SUBJECT: Limerick Generating Station, Units 1 & 2
Additional Information for Auxiliary Systems
Branch Regarding SER Open Issue #2 (Tornado
Missile Effects on Ultimate Heat Sink)

RESPONSES TO QUESTIONS AND REQUESTS FOR
ADDITIONAL INFORMATION ON
NUS-4507 REPORT

"LIMERICK GENERATING STATION UHS EXTREME WIND HAZARD ANALYSIS"

August 1984

Figure 1. Comparison of TORMIS and NRC hazard curves.

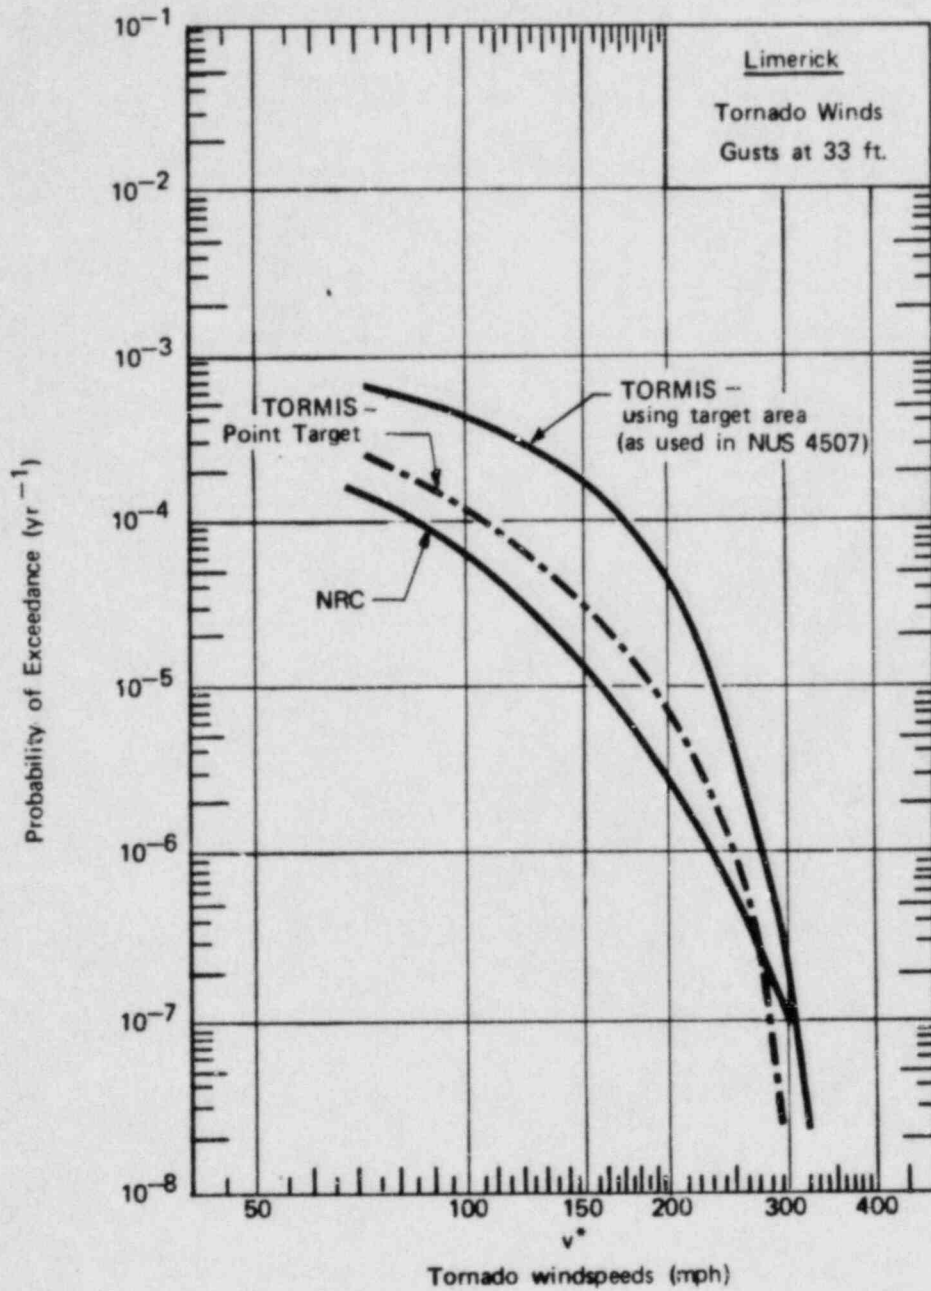
Q1. Document the basis for concluding that the analysis is a conservative, rather than a realistic one. The discussion should address all stages of the analysis presented in the NUS report. It is requested in particular, that the conservatisms associated with the tornado characteristics of length, width, and gradation of intensity within the path, and the treatment of the uncertainties in those characteristics, be addressed.

A quantitative demonstration of the conservatisms in the analysis and an overall test of the tornado hazard model can be obtained from comparison of results to those of other models; in particular, the NRC developed hazard curve (Ref. 22) for Limerick. Figure 1 compares the tornado hazard curve developed using the TORMIS methodology (Figure 3-3a of NUS-4507, Ref. 23) with the NRC curve. The curve used in the Limerick tornado wind and missile analysis represents the frequency with which the windspeed at any point on the target exceeds the specified velocity is very conservative relative to the NRC curve over the entire range of windspeeds of concern. The curve is a factor of 7 to 10 more conservative than the NRC curve for speeds less than about 260 mph. Hence, on the basis of this quantitative comparison, the TORMIS tornado hazard methodology and results for the Limerick analysis are conservative. Had the NRC curve been used in the Limerick UHS analysis, the F4 tornado contribution to the failure criteria would have been a factor of 10 less and the F5 contribution a factor of 2 less. The final results in the NUS-4507 (Ref. 23) would then be:

<u>As Reported TORMIS Hazard Curve</u>	<u>Updated with NRC Hazard Curve</u>
Event T	6.6×10^{-7}	8.2×10^{-8}
Event V	7.9×10^{-7}	1.1×10^{-7}

In summary, the tornado hazard curve used in NUS-4507 is very conservative relative to the NRC curve which was developed using different assumptions but which is also believed to be conservative.

Figure 2. Points at which Horizontal Windspeeds Were Calculated

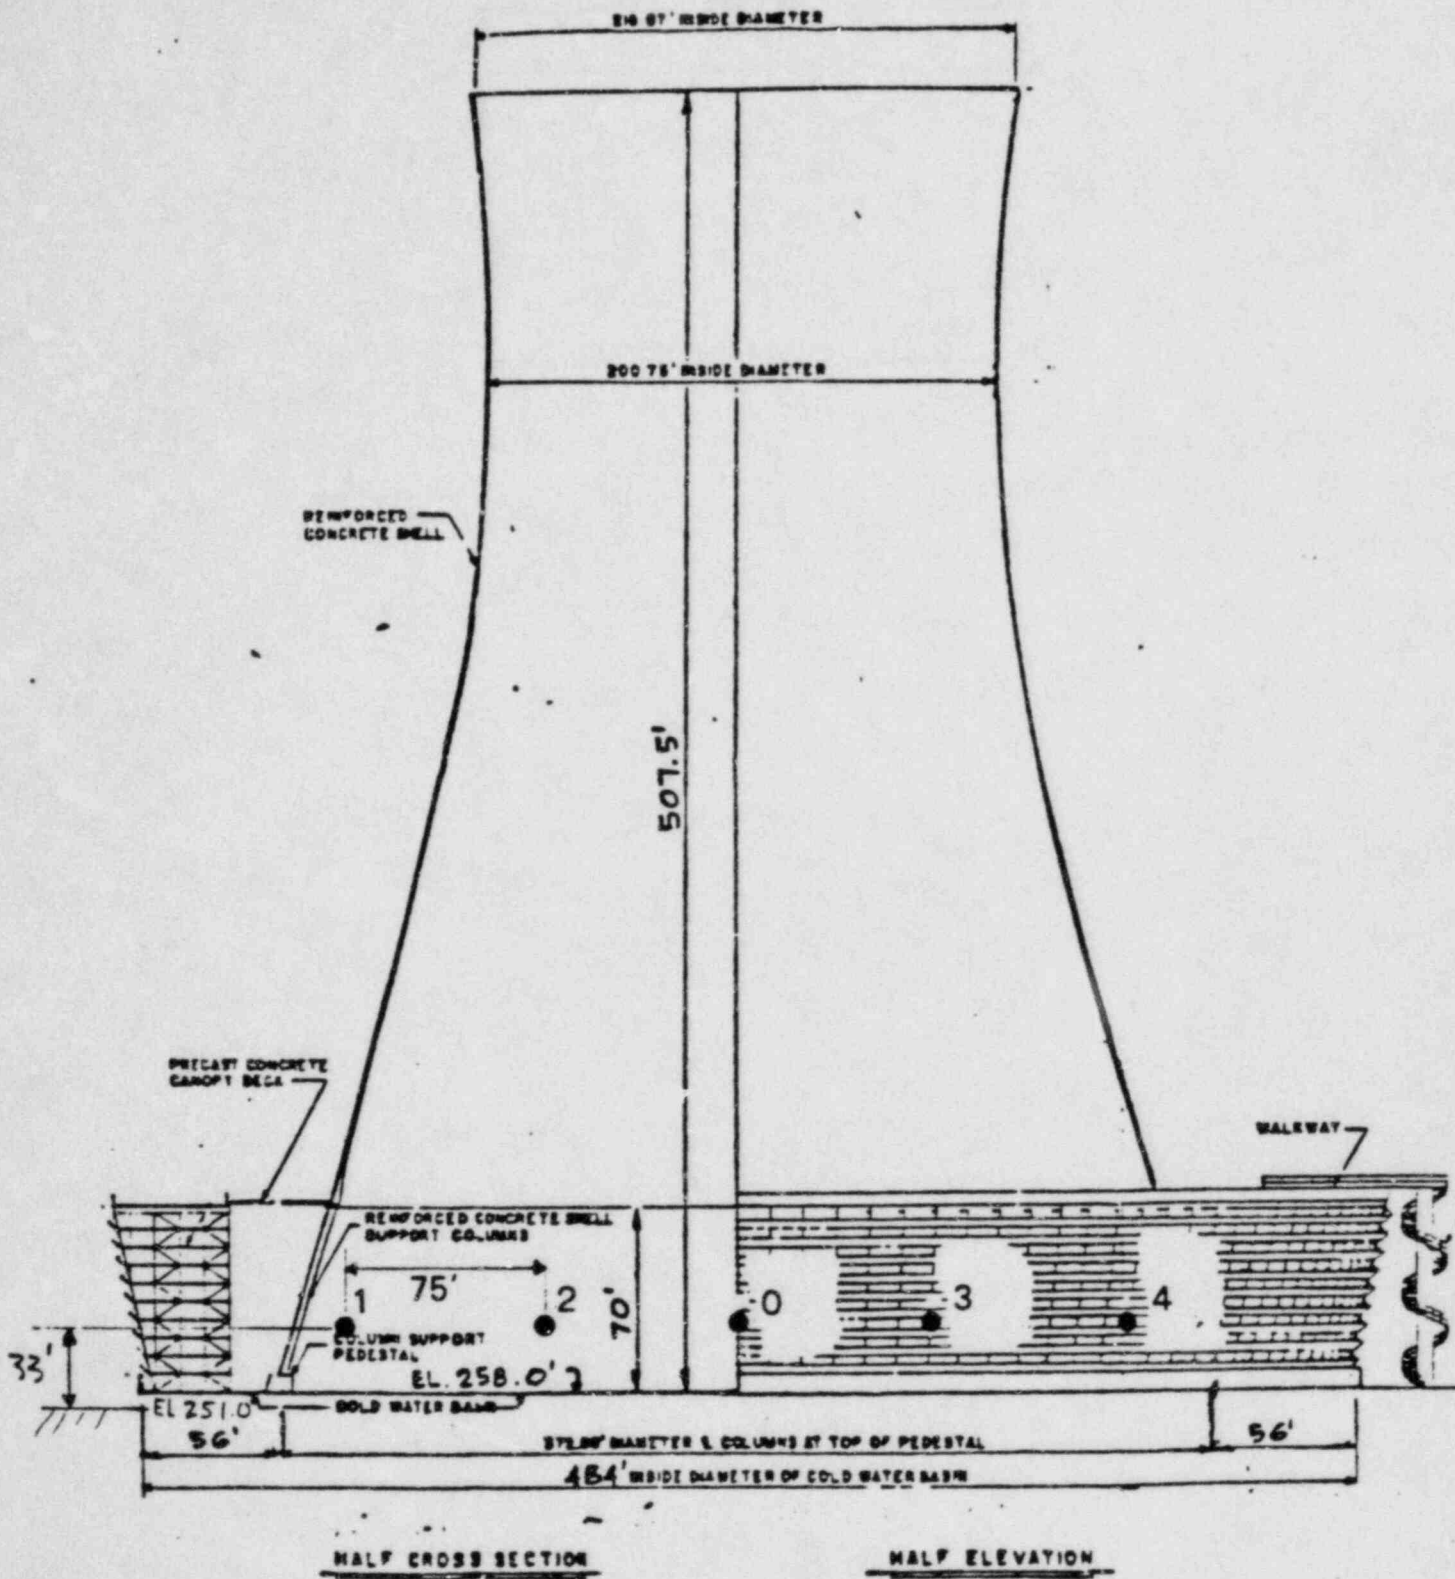
Q3. The failure criterion adopted for the cooling towers is that the cooling towers fail if the windspeed exceeds 140 mph at the center of the tower, at mid-height. It is possible that a portion of the tower can experience wind speeds in excess of 140 mph while the center of the tower does not. Discuss the significance of this with respect to any potential lack of conservatism, that is, should the 140 mph windspeeds just touching the tower be the conservative failure criterion?

In order to assess the likelihood that some part of the cooling tower might experience winds in excess of 135 mph at 33 ft elevation when the windspeed at the center is less than 135 mph, $P(V_m \geq 135 | V_0 \leq 135)$, a TORMIS simulation was performed with additional check points on windspeed exceedance. As shown in Figure 2 five points were chosen at 75 ft spacing and 33 ft elevation in a vertical plane containing the center line of the tower and normal to the tornado direction of travel. One thousand tornadoes were simulated in each of the F2-F5 intensity levels and the maximum horizontal windspeed V_0 at tower center (point 0) on each cooling tower for each tornado was calculated. For each tornado for which V_0 did not exceed 135 mph, the maximum windspeeds, V_1 through V_4 , at the other points were calculated. Letting V_m be the maximum of these ($V_m = \max\{V_i\}$, $i = 1, 2, 3, 4$) the scoring of one of seven mutually exclusive and collectively exhaustive events was as follows:

From these results the following estimates, averaged over both cooling towers were constructed:

Table 6 summarizes these results. They indicate that only 3, 12, 14, and 14 percent of F2, F3, F4, and F5 tornadoes, respectively, would produce winds in excess of 135 mph on the tower given that the center of tower experience winds ≤ 135 mph. For V_m to significantly exceed 135 mph, say $V_m \geq 165$ mph, these probabilities are 0, 0.04, 0.08, and 0.07, respectively. Hence, these results indicate that the error introduced by using tower center point is not significant, considering the other conservatisms in the analysis.

Figure 4. **TORMIS Tornado Wind Profile Corresponding to Tower Failure**

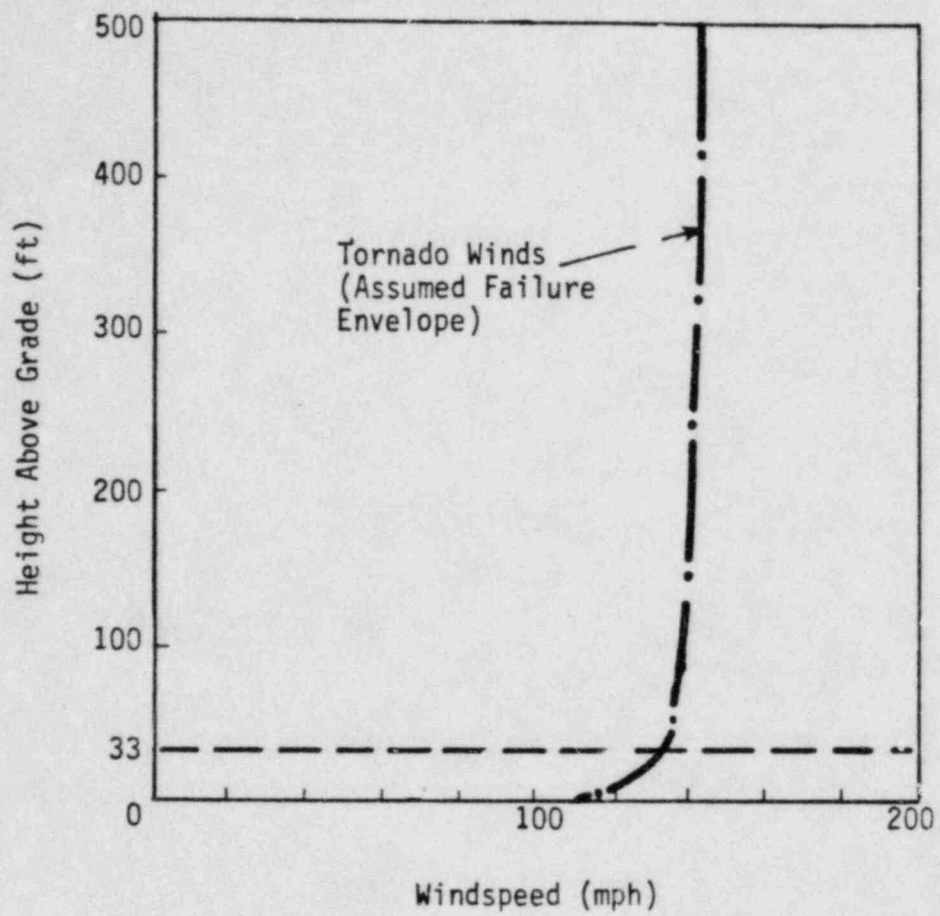
Q5. What is the value of the tornado wind speed at an elevation of 33 ft which corresponds to the nominal failure of the cooling towers? Are the results of the simulations in the NJS report compatible with these values?

NUS-4507 reported a tower failure speed of 140 mph at tower midheight. This speed, on the basis of published TORMIS wind profiles (2), is consistent with the 135 mph at 33 ft and was reported on that basis. Figure 4 illustrates this profile variation of tornado windspeed with height. The midheight speed was reported since it was felt that midheight was a more useful engineering reference than 33 ft for towers of 500 ft height. Considering the practical aspects of predicting tower failure, the TORMIS tornado wind profile can be treated as essentially uniform above 33 ft.

These results were obtained from simulations at various offsets, including large offsets where the windspeeds are dominated by the translational velocity, and thus do not show much vertical variation. Hence, the above ratios may be slightly small for estimating windspeeds at 250 ft corresponding to tower failure windspeeds of 135 mph at 33 ft. For example, the average ratio of five F3 tornadoes, selected at random, whose maximum windspeeds at 33 ft were between 119 and 159 mph (i.e., near the 135 mph value) was $V_{250}/V_{33} = 1.048$. On this basis, the 250 ft windspeed corresponding to 135 mph at 33 ft would be 141.5 mph.

Thus, it has been concluded that maximum horizontal windspeeds at tower midheight would generally be between 134 and 142 mph when the maximum windspeeds at 33 ft were 135 mph. The results reported in NUS-4507 are consistent with these values.
